DART SERVICE INSTRUCTION

TO AMEND INSTALLATION INSTRUCTIONS D350-602 REV E (OR EARLIER REV.)
AND INSTRUCTIONS FOR CONTINUOUS AIRWORTHINESS ICA-D350-602 REV. 0

REF. TCCA STC: SH93-97
REF. FAA STC: SR01144NY
REF. EASA STC: EASA.IM.R.S.01290

Dart Heli-Utility-Pods D350-602-011 @ CHG 006 and D350-602-013/-014 @ CHG 002 have new attachment lugs.

FIGURE 1: Aft Crosstube Attachment
(Installation of D4091-1 / D3910-3 Lugs)

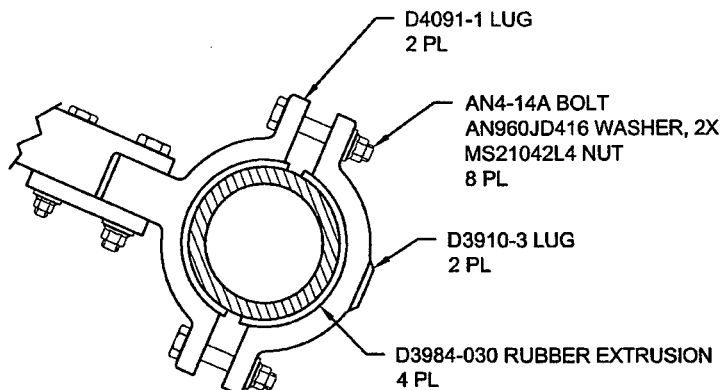
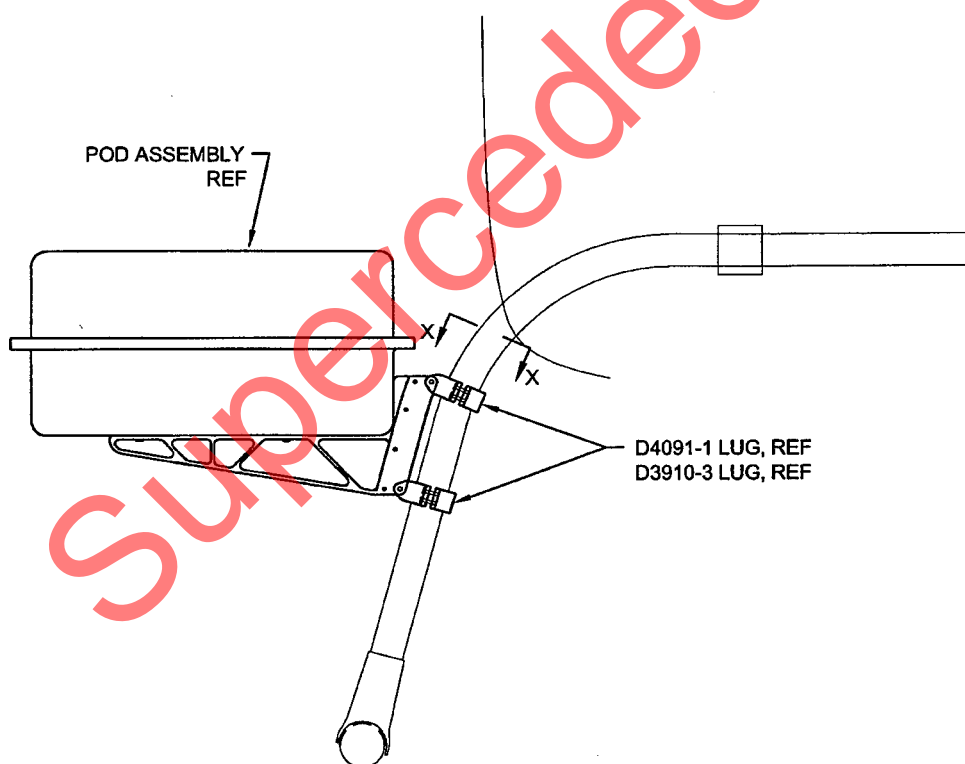
The D2230-1/-3 clamps are replaced with wider D4091-1/D3910-3 lugs. The abrasion strip is replaced with D3984-030 rubber extrusion. The D2462-1700 Neoprene Seal is replaced with D2461-1700 Neoprene 'D' Seal. The modified parts list for Installation Instruction D350-602 and Instructions for Continued Airworthiness ICA-D350-602 is shown on sheet 2 of this service instruction. Install the lugs as shown in Figure 1 & 2 of this service instruction. The pod should otherwise be installed per D350-602 and maintained per ICA-D350-602.

The Dart DSI-9515-011 kit is available to upgrade D350-602-XXX Heli-Utility-Pods made to earlier change numbers with D4091-1 / D3910-3 lugs. The lugs should be installed per Figure 1 & 2 of this service instruction.
